TO: CEO Michael L. Thurmond, Dekalb County
ATTN TO: Larry Washington, Planning Administrator, Dekalb County
FROM: Mike Alexander, Director, ARC Center for Livable Communities
RE: Development of Regional Impact (DRI) Review

Name of Proposal: North Dekalb Mall Redevelopment DRI 3582

Submitting Local Government: Dekalb County

Drawing name: K:\ALP_PRJ\01838\014_North Dekalb Mall\CAD\Plansheets\C1-50 - DRI SITE PLAN.dwg C1-50 REZONING SITE PLAN Mar 17, 2022 4:17pm By: Taylor Jones

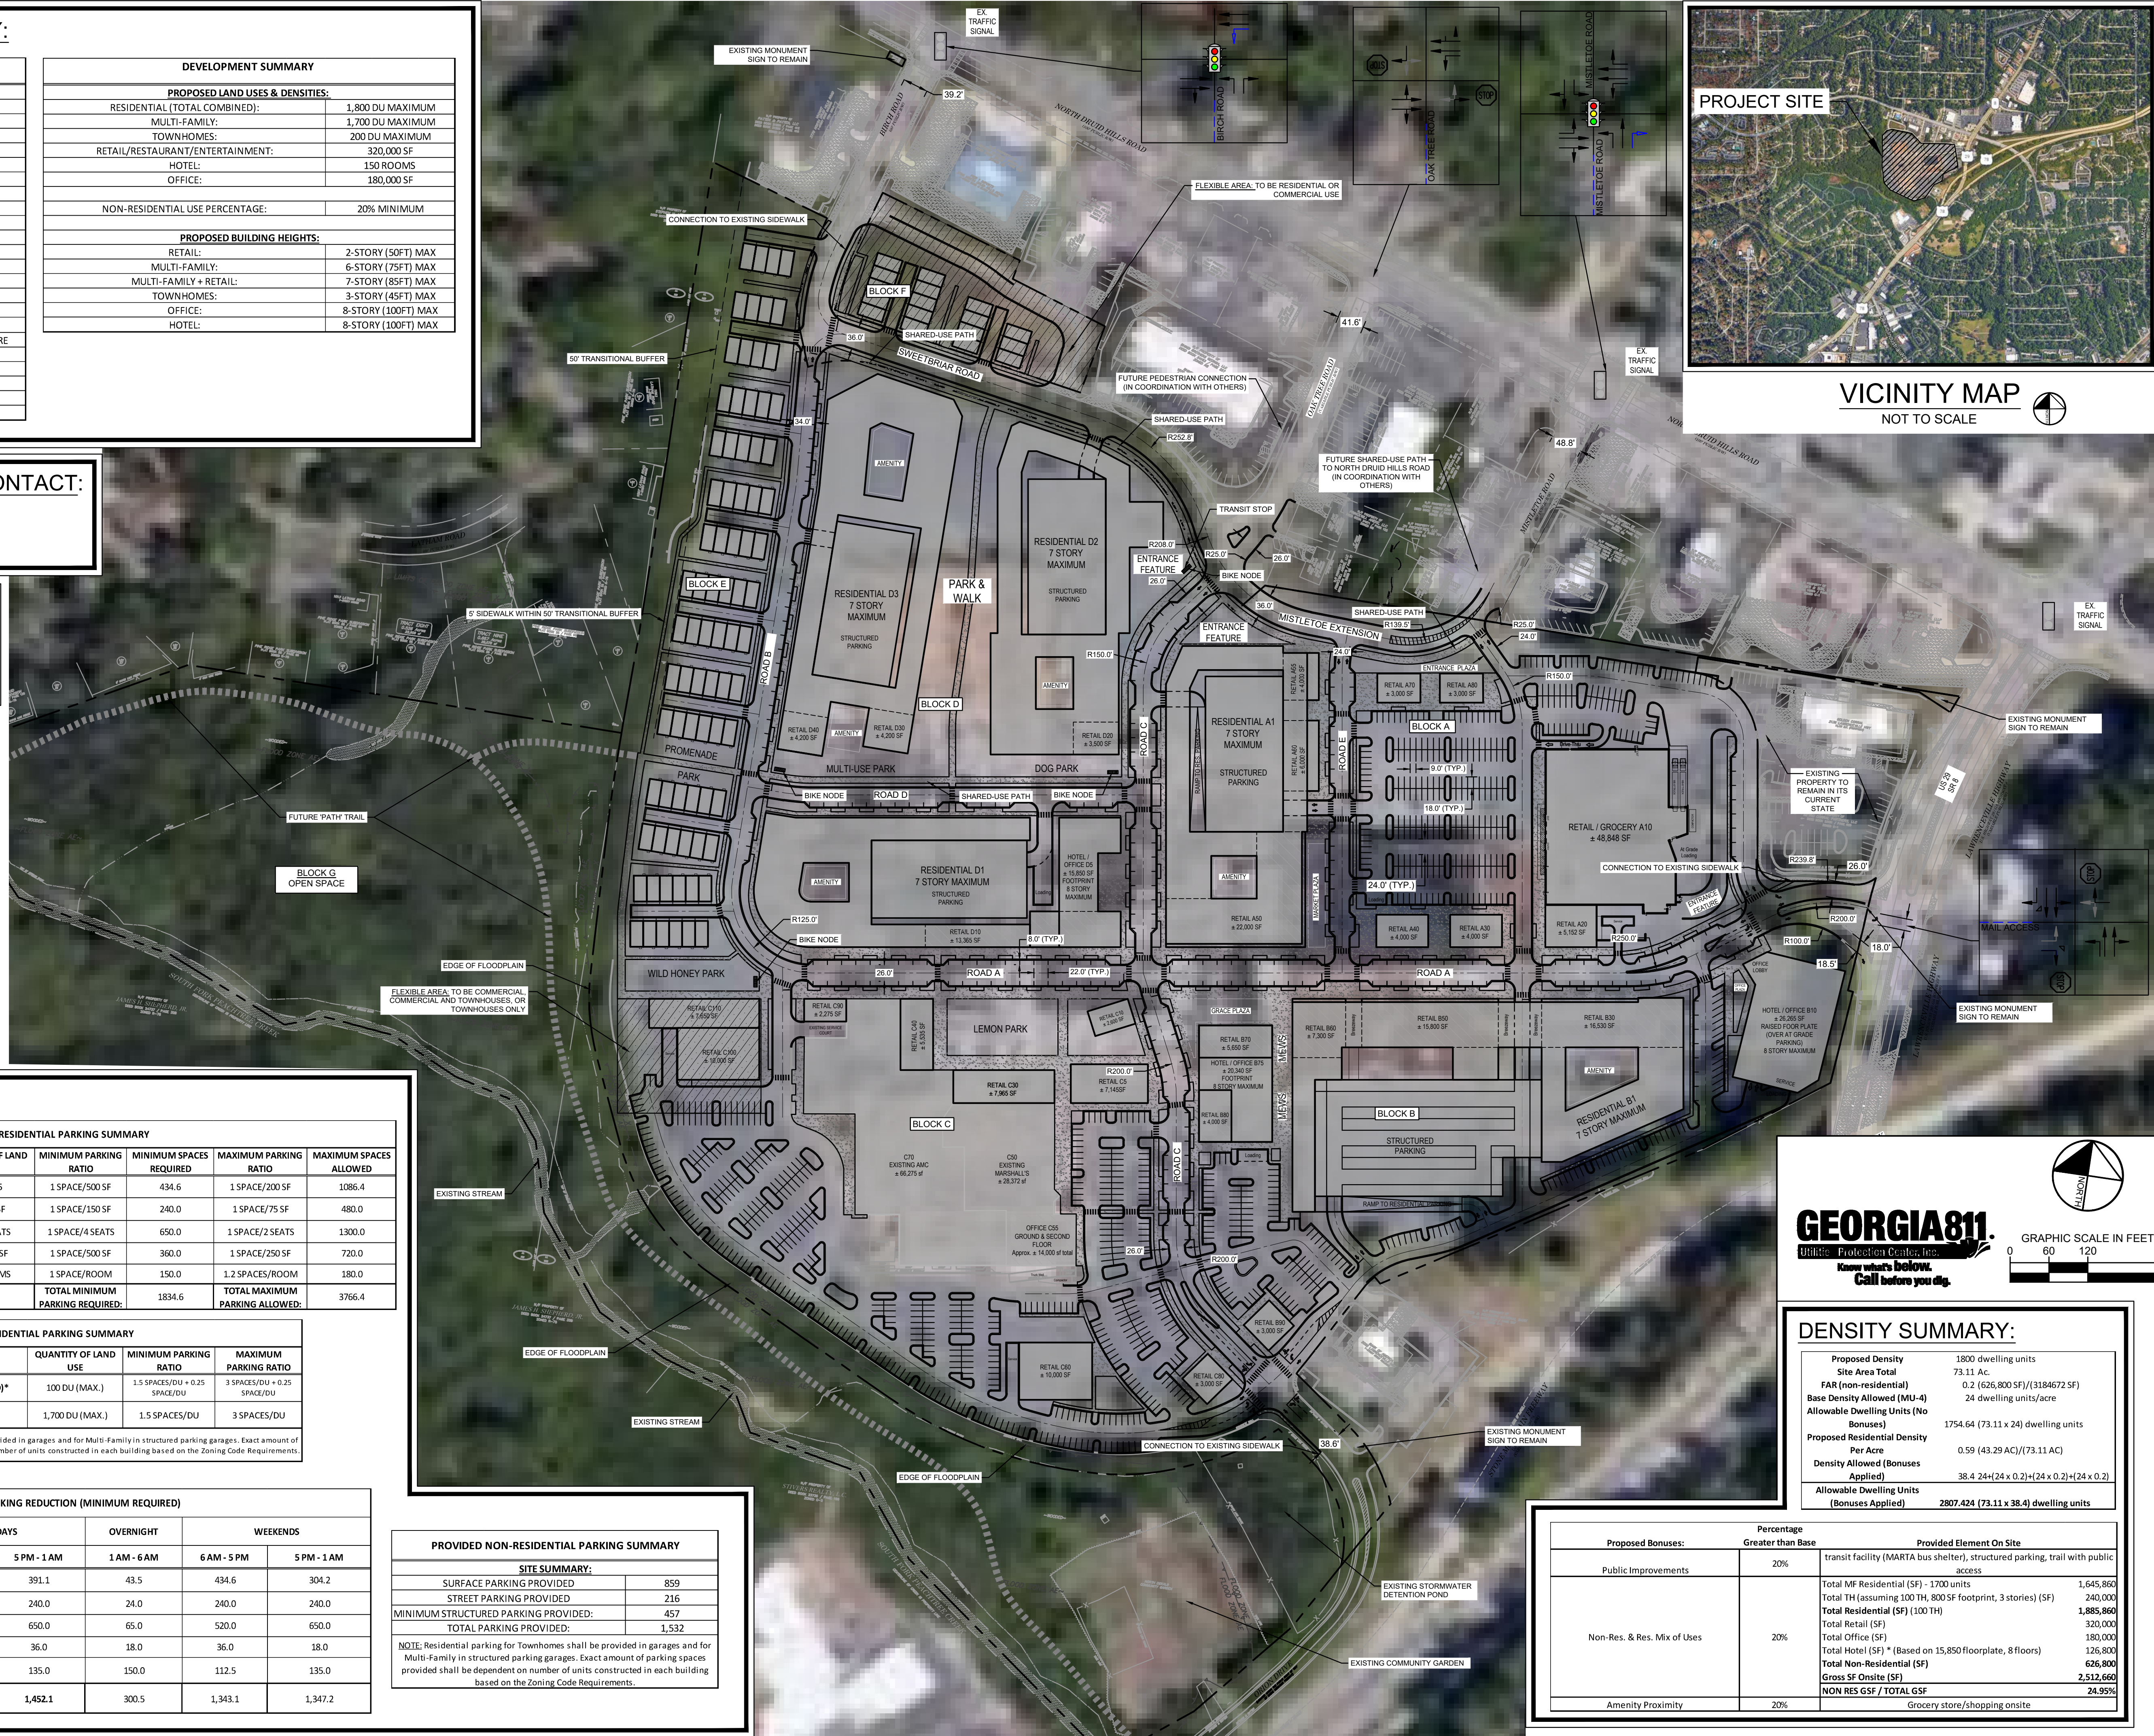
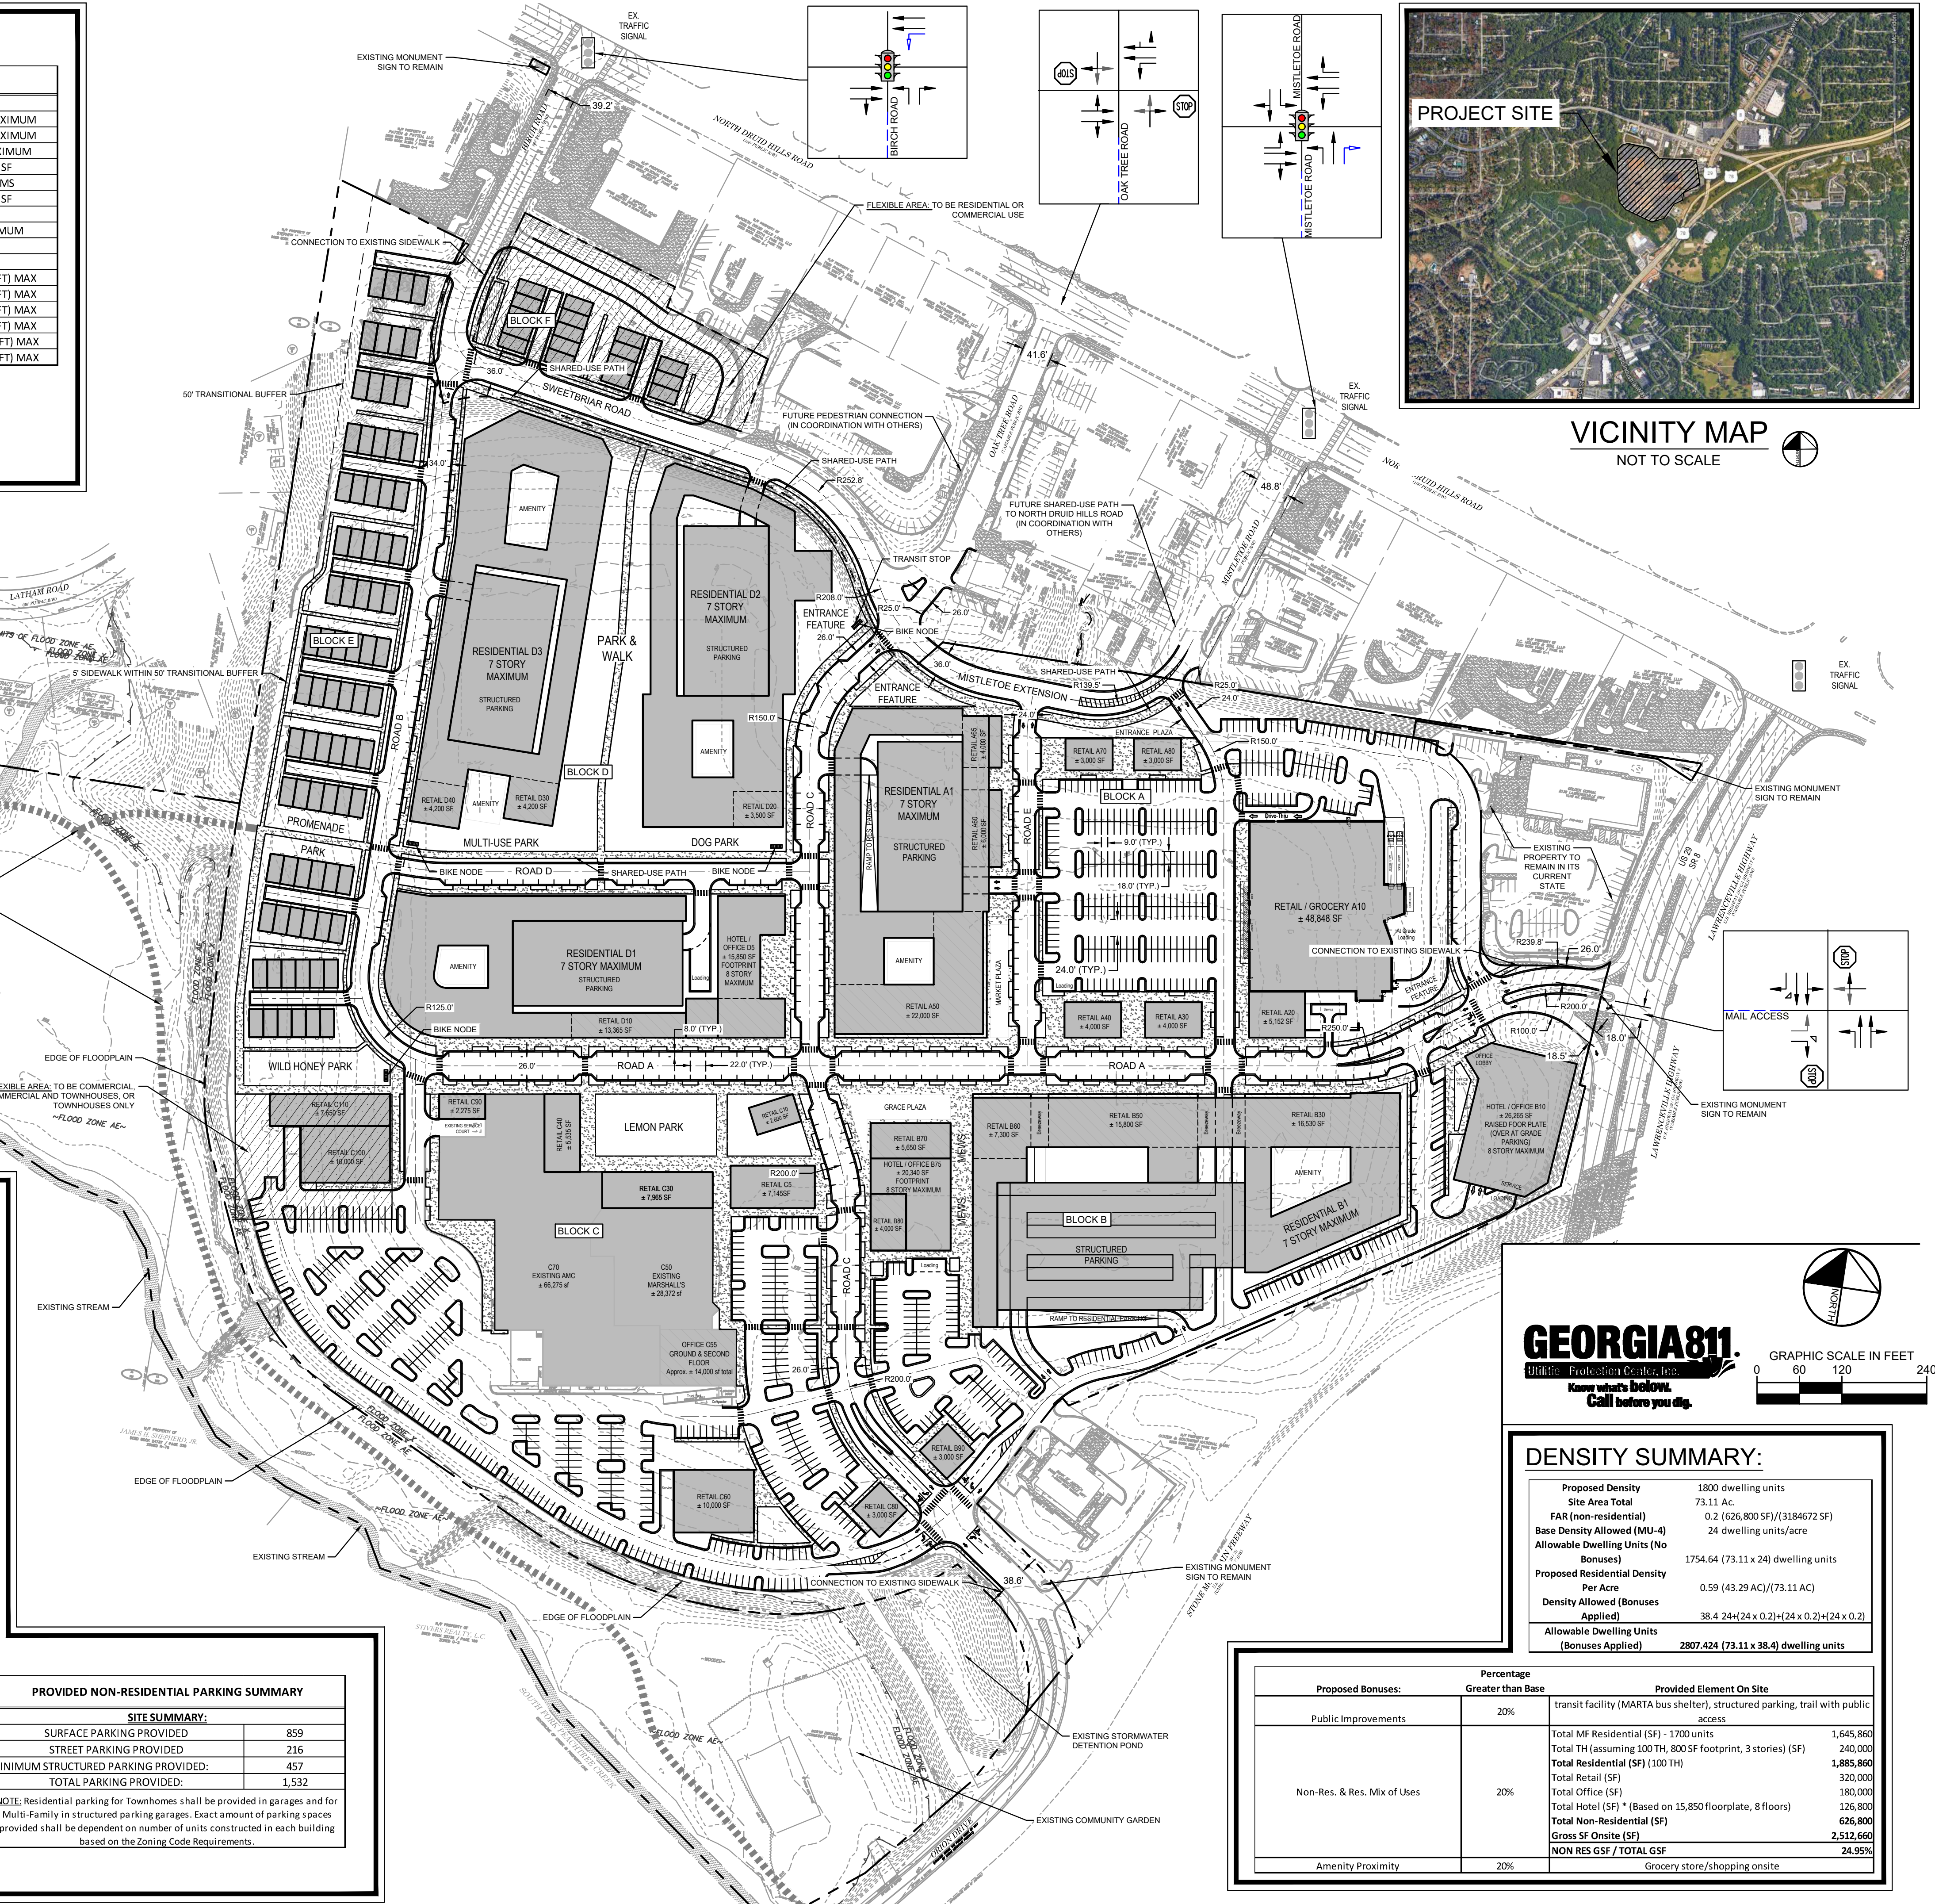
A total of 1,532 non-residential parking spaces are proposed in a mix of surface, street, and structured parking facilities.

The site plan and the USGS coverage for the project area show the South Fork of Peachtree Creek forming the southwestern and western boundaries of the project property. The site plan also shows an unnamed tributary to the South Fork of Peachtree in the western end of the property. Neither the County 75-foot stream buffer or 25-foot State Sediment and Erosion Control buffer are shown along the streams. However, both are entirely within the conservation area portion of the project, which extends beyond the width of the buffers. The only proposed activity shown in the conservation area is a proposed future trail paralleling the South Fork of Peachtree Creek. Given that paths are allowed in the buffer under the DeKalb ordinance, a variance may not be needed outside the 25-foot State buffer. Any unmapped streams on the property may also be subject to the City buffer ordinance. Any unmapped State waters identified on the property may also be subject to the State 25-foot Sediment and Erosion Control buffer.

The site plan and the USGS coverage for the project area show the South Fork of Peachtree Creek forming the southwestern and western boundaries of the project property. The site plan also shows an unnamed tributary to the South Fork of Peachtree in the western end of the property. Neither the County 75-foot stream buffer or 25-foot State Sediment and Erosion Control buffer are shown along the streams. However, both are entirely within the conservation area portion of the project, which extends beyond the width of the buffers. The only proposed activity shown in the conservation area is a proposed future trail paralleling the South Fork of Peachtree Creek. Given that paths are allowed in the buffer under the DeKalb ordinance, a variance may not be needed outside the 25-foot State buffer. Any unmapped streams on the property may also be subject to the City buffer ordinance. Any unmapped State waters identified on the property may also be subject to the State 25-foot Sediment and Erosion Control buffer.
